Hanlon – Deerfield Elementary School Project

School Building Committee Meeting

11 February 2022

Construction Cost Management

OVERALL 1ST FLOOR PLAN: Frame of Reference

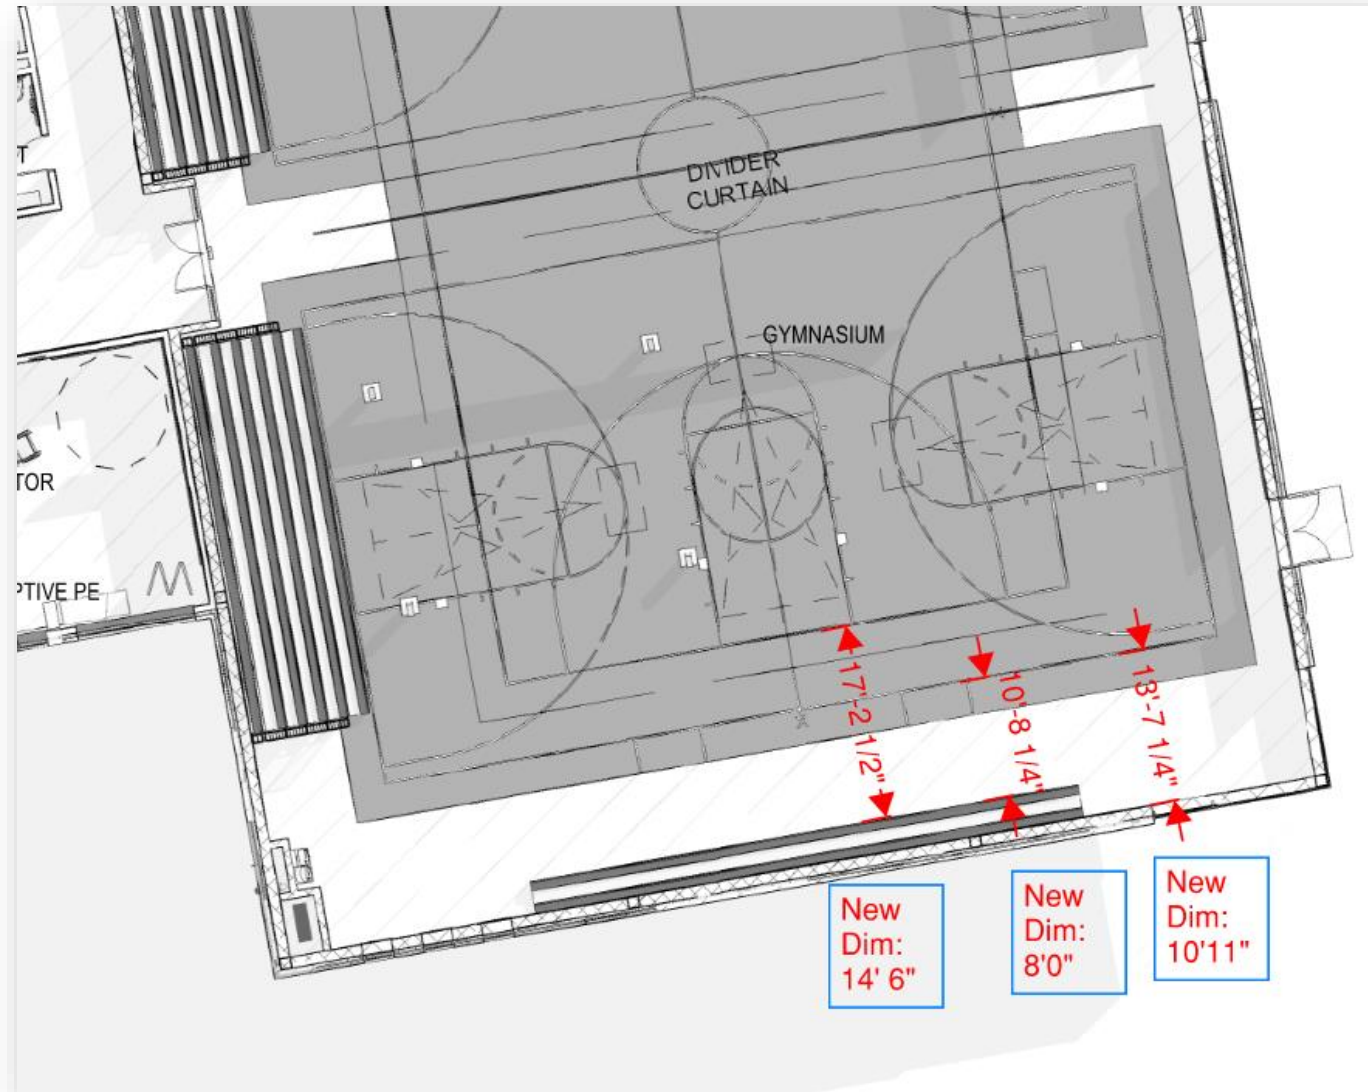
1. Value Management at GYM: Reduce gym square footage

Value Management at Gym:

Move southern wall to the north, shortening length of Gym by 2'8"

2. Value Management at “NECK” – Possible Revisions

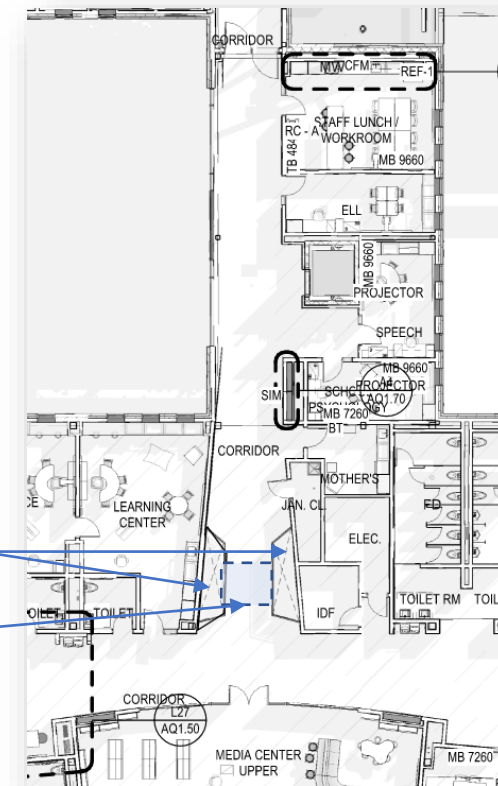
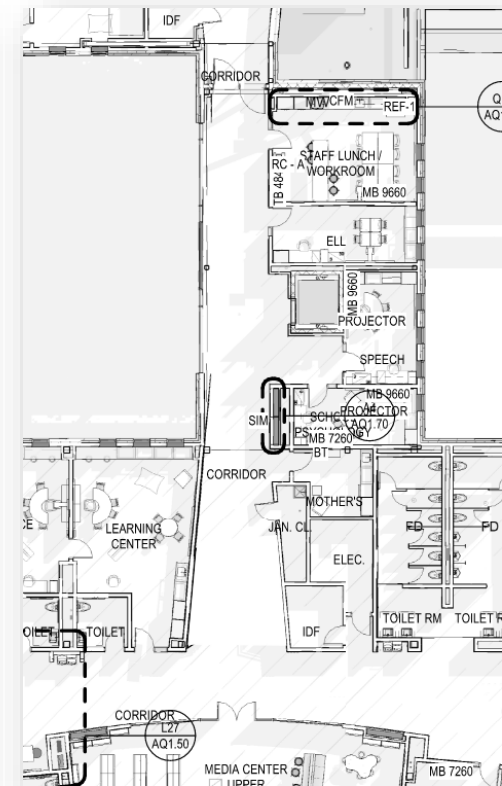
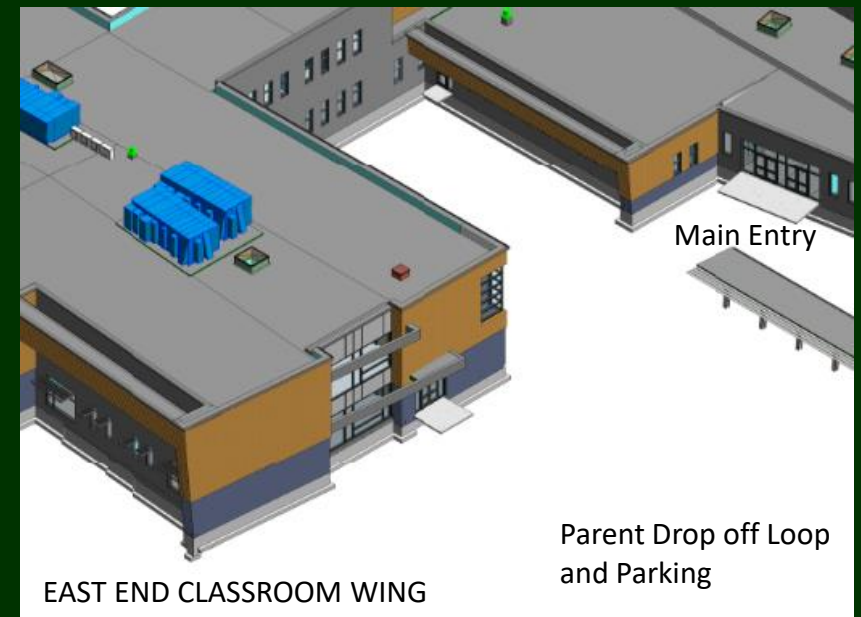
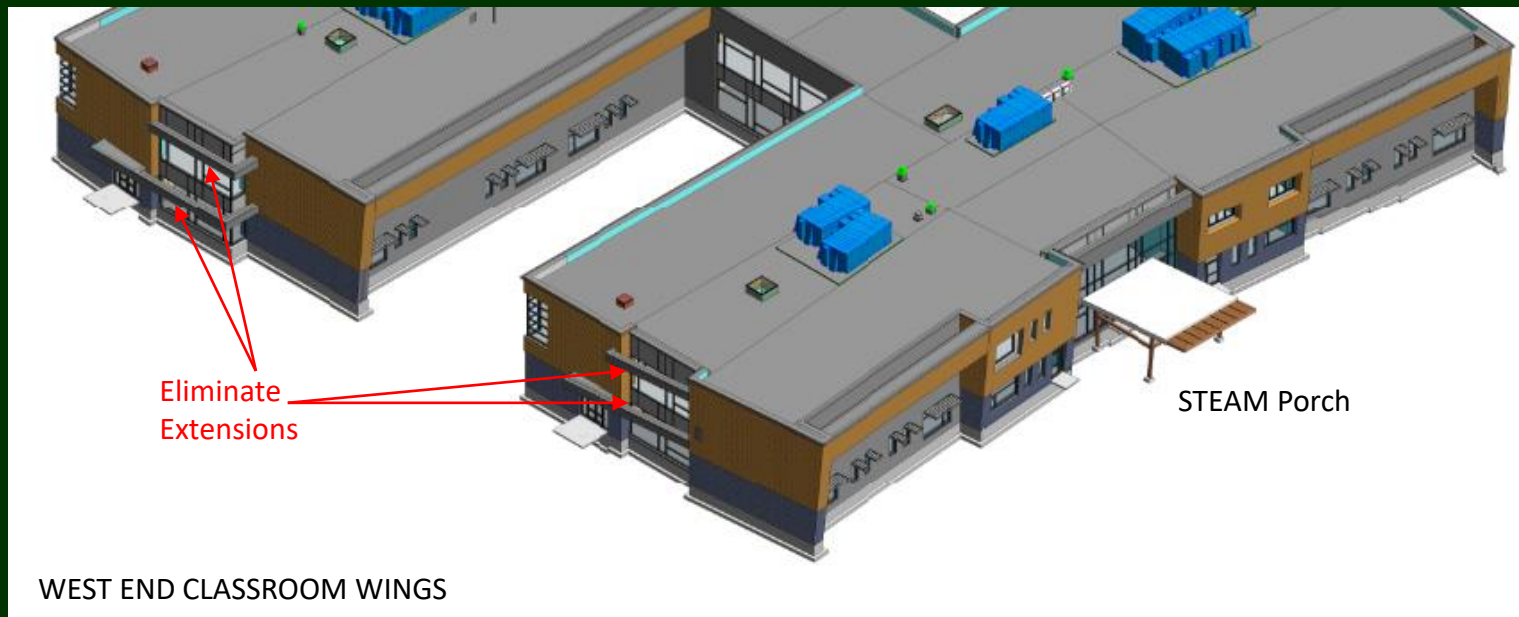
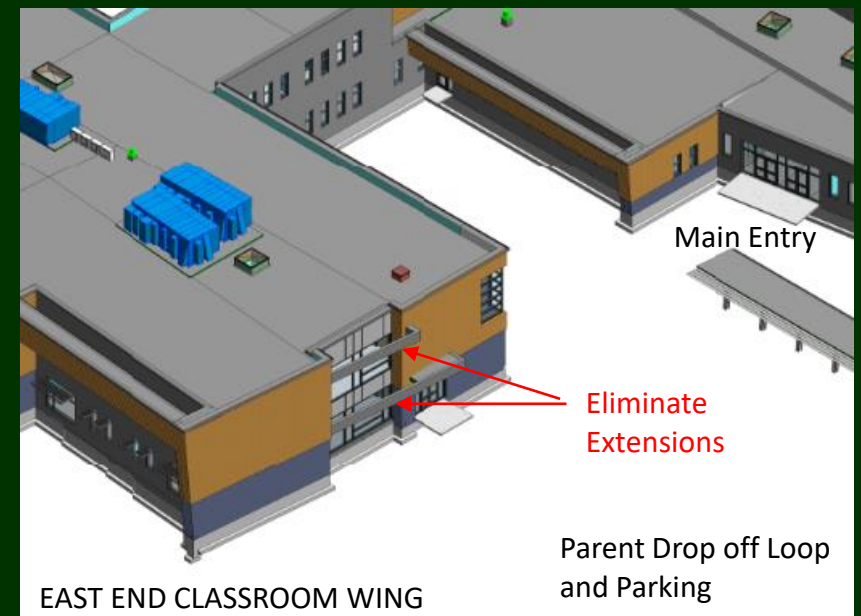
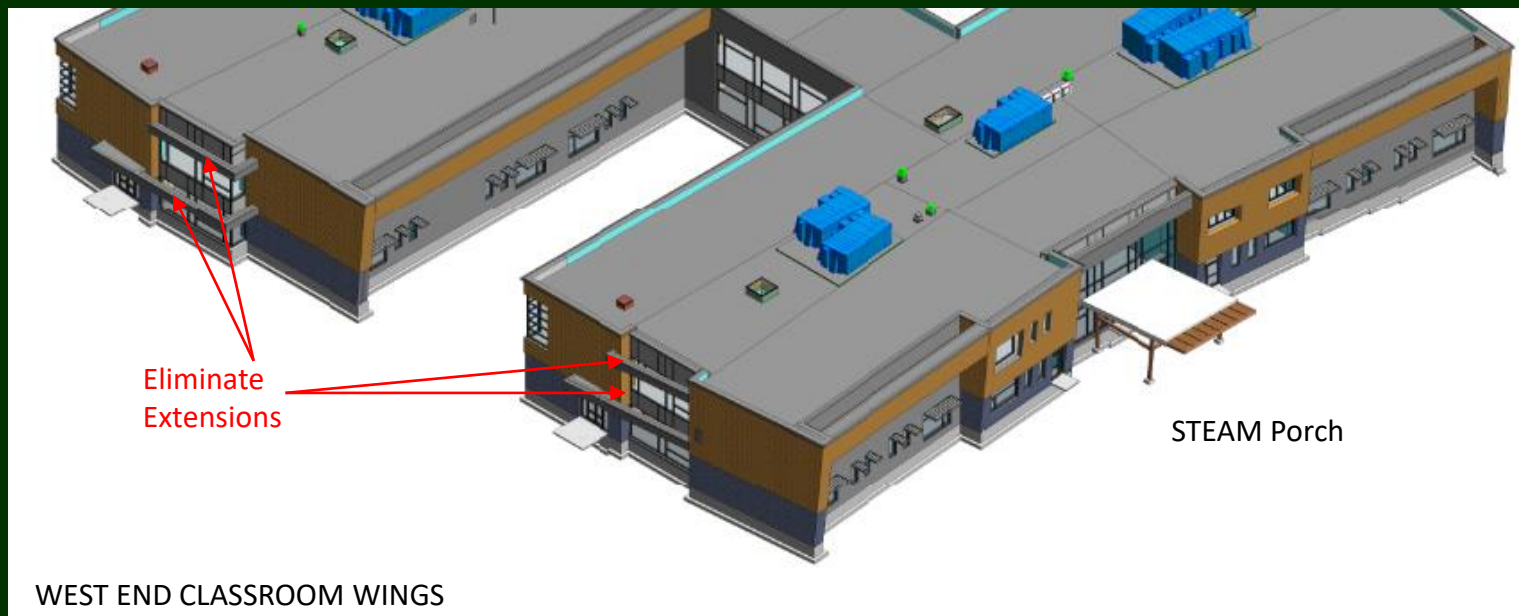
“Neck” – Current Plan

“Neck” – Eliminate
“Open to Below” floor
openings and skylight

4. Value Management: Gallery Stair and Acoustical Panels

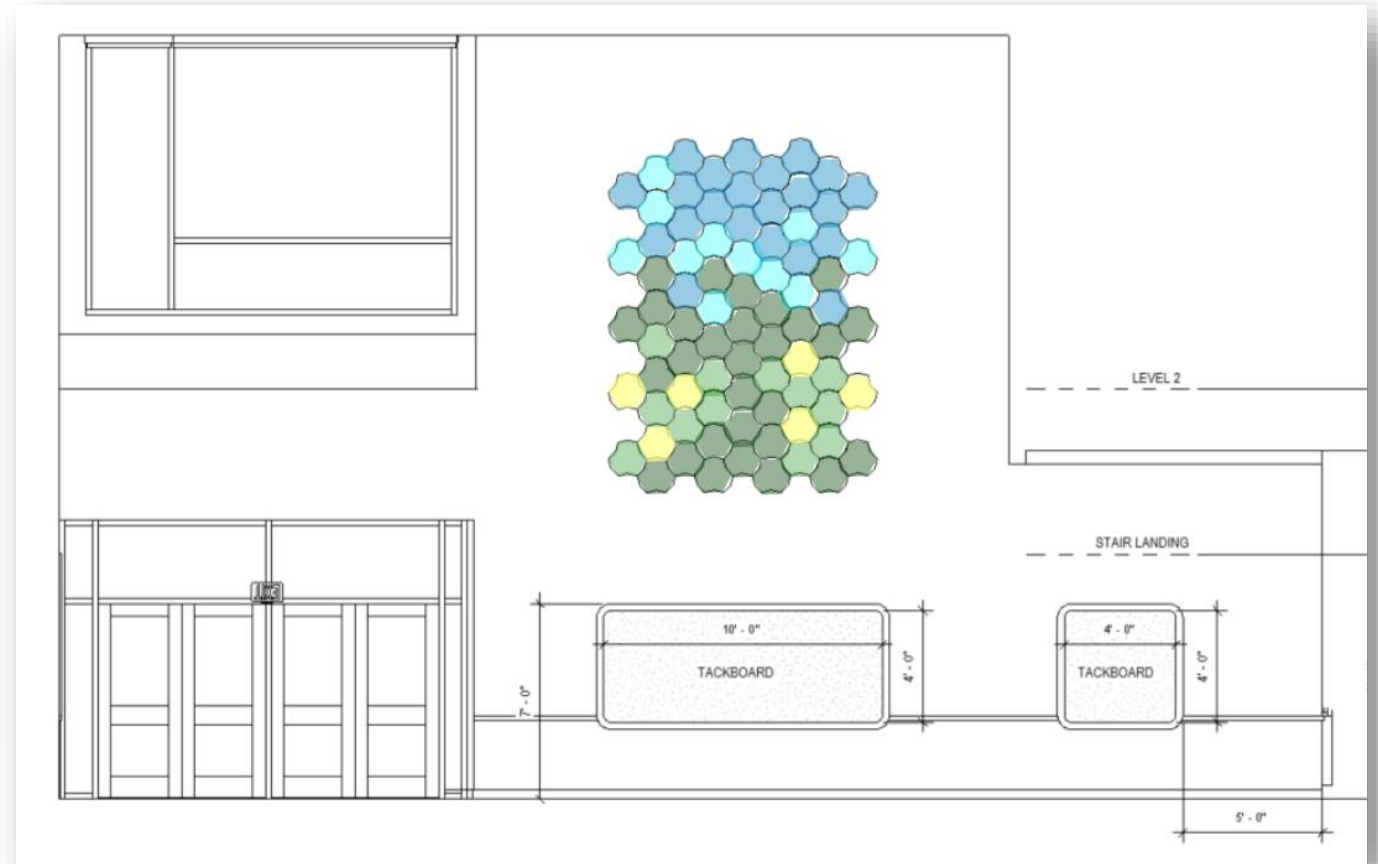
Reconfiguring the stair from “U” shape to “L” shape

Reducing acoustical panels and wood trim

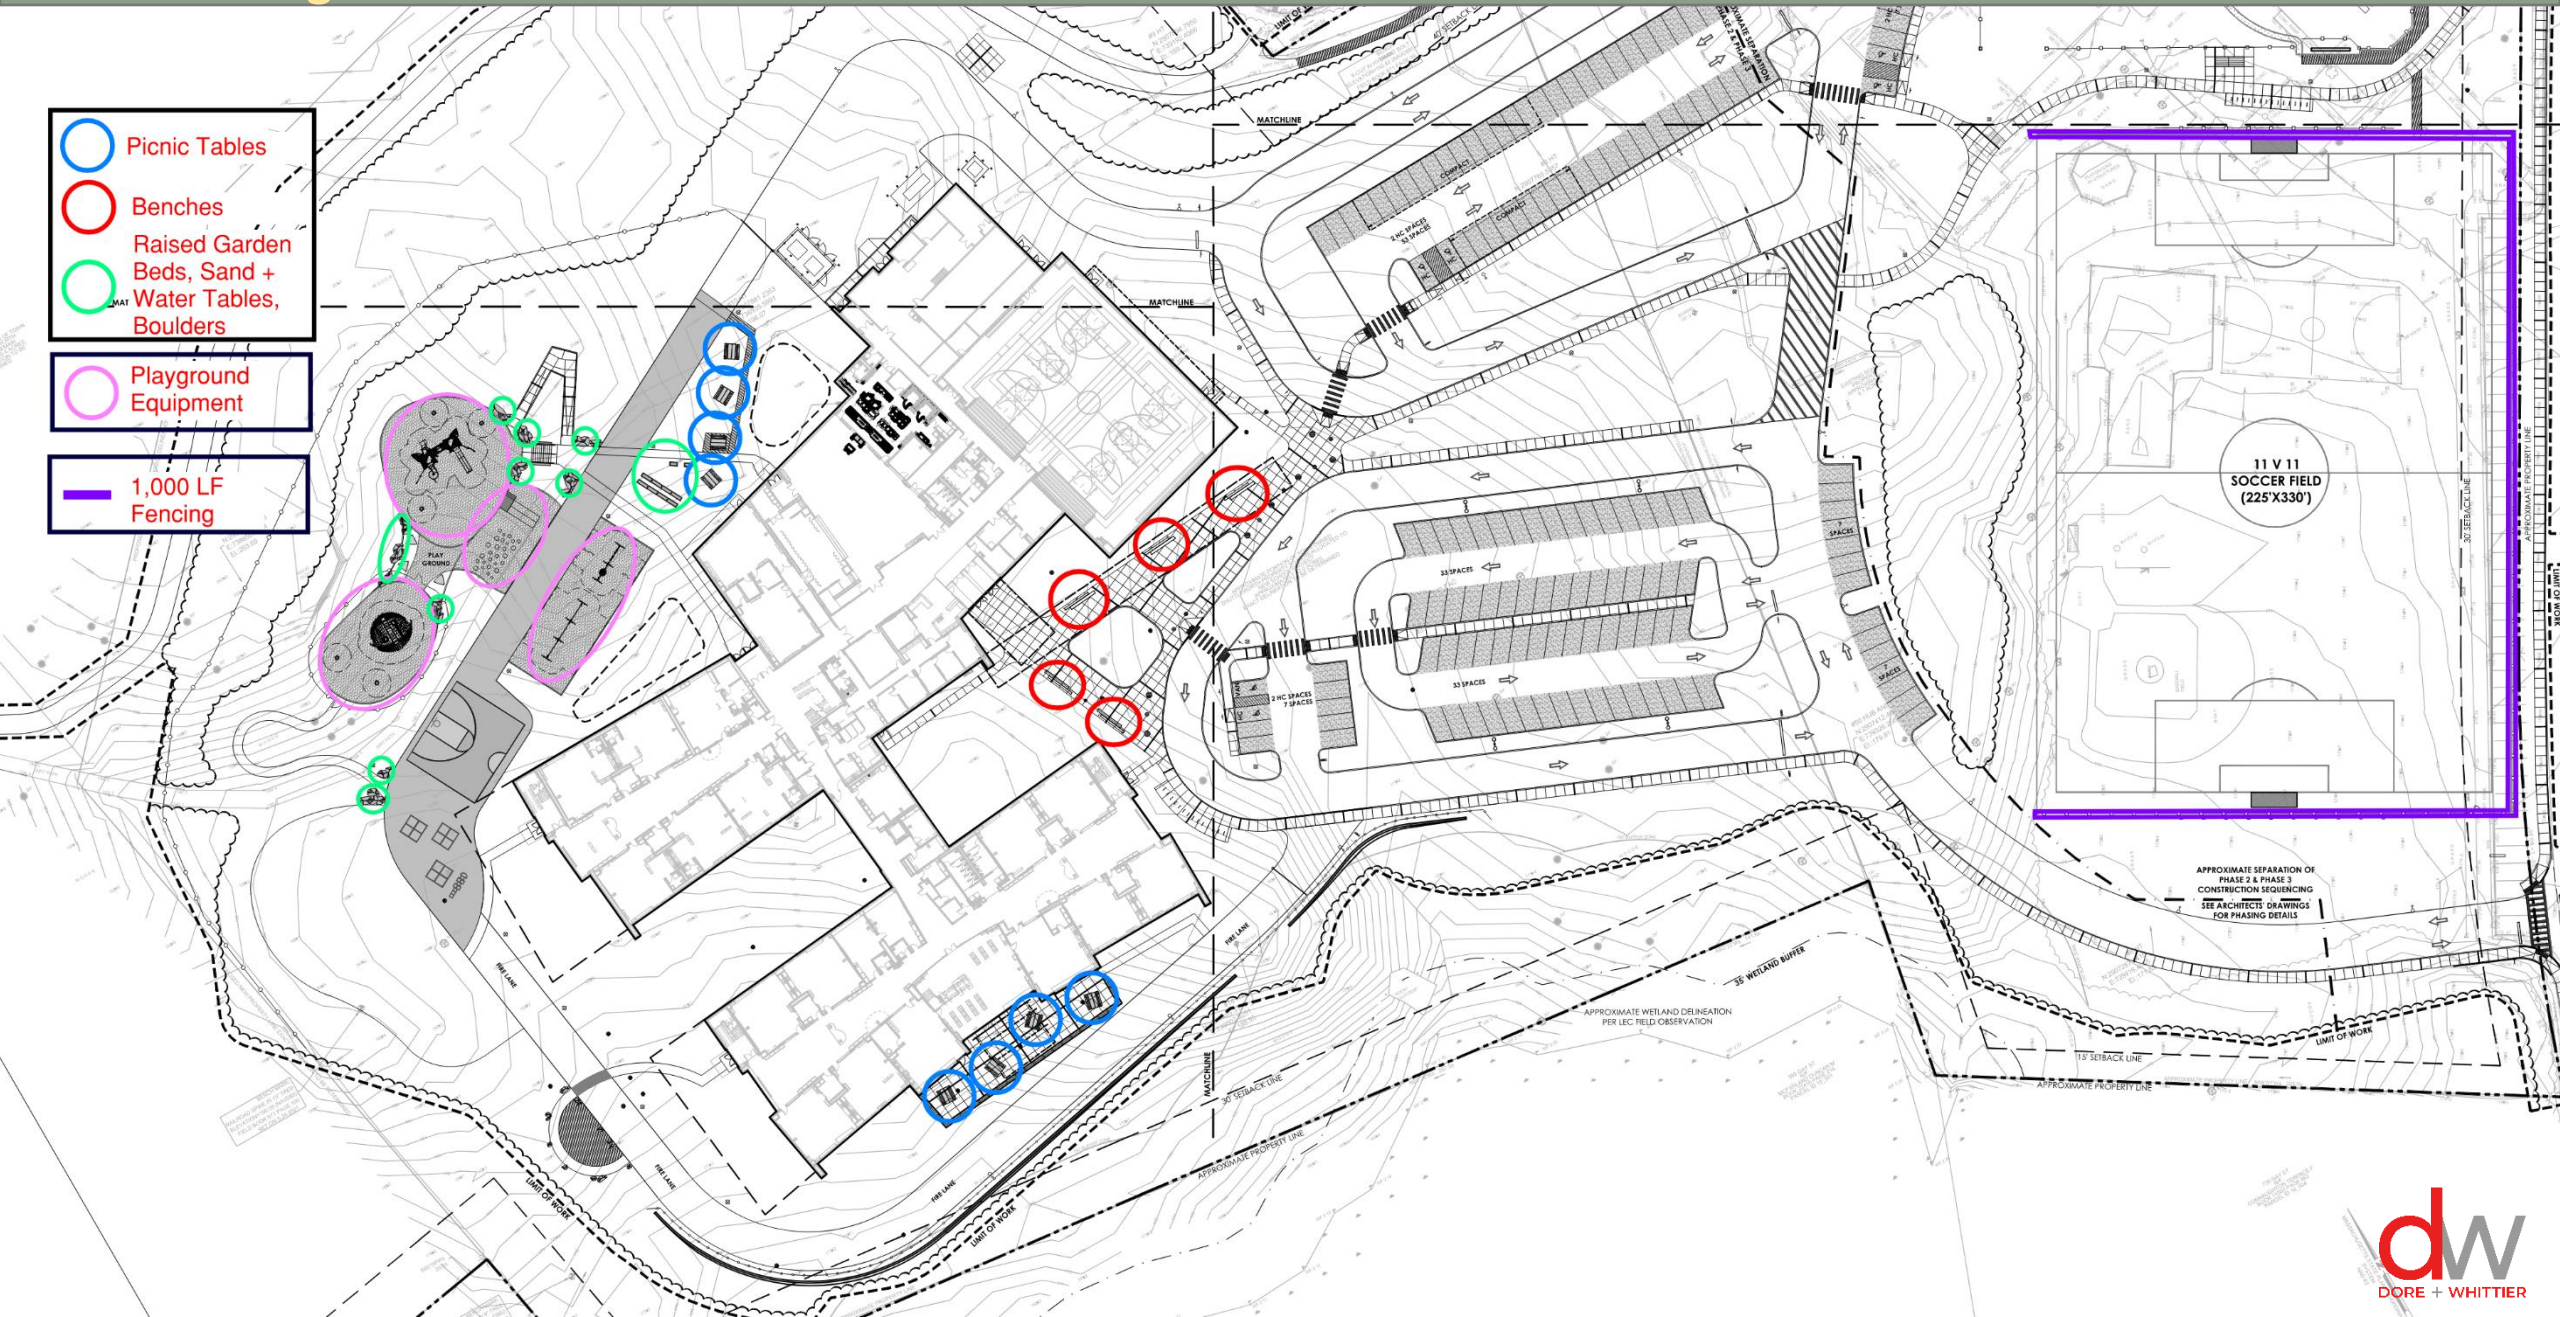
SCOPE to convert to alternates	Estimated Cost Reduction*
Landscape boulders and site furnishings: raised gardens, sand/water tables, benches, picnic tables, etc.	\$ (102,332)
All smaller playground equipment. Two large structures in base	\$ (170,000) **
Chain link fencing around field	\$ (65,000)
Subtotal	\$ (337,332)

-  Picnic Tables
-  Benches
-  Raised Garden Beds, Sand + Water Tables, Boulders
-  Playground Equipment
-  1,000 LF Fencing
